Access Compliance Report

Public Rights-of-Way

(Curb Ramps)

Intersection ID: 43648	Main Street: CAMDEN_MEADOW_DR	Cross Street: SWANN_BRANCH_DR	Location: SE
ADA ID: 6A3D5C4305E4	Ramp Type: PerpDiag	Initial Pass/Fail: Fail	Overall Compliance: No
Severity Score: 21.25			
Codes/Mitigation Info/Possible Solution		Field Measurements/Component Compliance

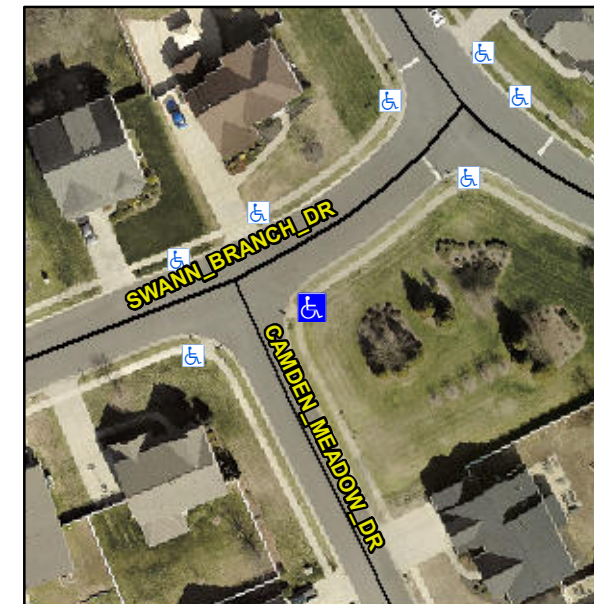
Not Found, R304.5.1, R304.2.2

Compliance	Description	Data	Compliance	Description	Data
N/A	Ramp Length (in)	52.0	No	Ramp Slope (%)	8.4
No	Ramp Width (in)	37.0	Yes	Ramp XSlope (%)	0.3
N/A	Flare Type LT	N/A	N/A	Flare Type RT	N/A
N/A	Flare Slope LT (%)	N/A	N/A	Flare Slope RT (%)	N/A
N/A	Flare Traversable LT?	N/A	N/A	Flare Traversable RT?	N/A
N/A	Landing Length (in)	N/A	N/A	DWS Provided?	N/A
N/A	Landing Width (in)	N/A	N/A	DWS Contrast?	N/A
N/A	Landing Slope (%)	N/A	N/A	DWS Length (in)	N/A
N/A	Landing X Slope (%)	N/A	N/A	DWS Full Width?	N/A
N/A	Landing Curb? (Y/N)	N/A	N/A	DWS Offset (in)	N/A
N/A	Shared Landing?	N/A			
N/A	Gutter Ponding?	N/A	N/A	Gutter Slope (%)	N/A
N/A	Gutter Lip Ht (in)	N/A	N/A	Gutter X Slope (%)	N/A
N/A	Painted X Walk1?	No	N/A	Painted X Walk2?	No
	X Walk 1 Direction	To N		X Walk 2 Direction	To W
N/A	X Walk 1 Width (in)	N/A	N/A	X Walk 2 Width (in)	N/A
	X Walk 1 Slope (%)	4.4		X Walk 2 Slope (%)	0.5
	X Walk 1 X Slope (%)	0.4		X Walk 2 X Slope (%)	2.1

N/A	Ramp inside XWalk1?	N/A	N/A	Ramp inside XWalk2?	N/A
	Road Slope (%)	0.5	N/A	Clear Space?	N/A
	Road X Slope (%)	1.8	N/A	Clear Space to XWalk (in)	N/A
N/A	Any Obstructions?	N/A	N/A	Storm Grate/Utility Hazard?	N/A
	Obstruction Type			Storm Grate/Utility Type	
		N/A			N/A
		Yes		Surface Condition? (G/P)	Good

Remove & Replace Curb Ramp With Two New Directional Ramps or Equivalent.
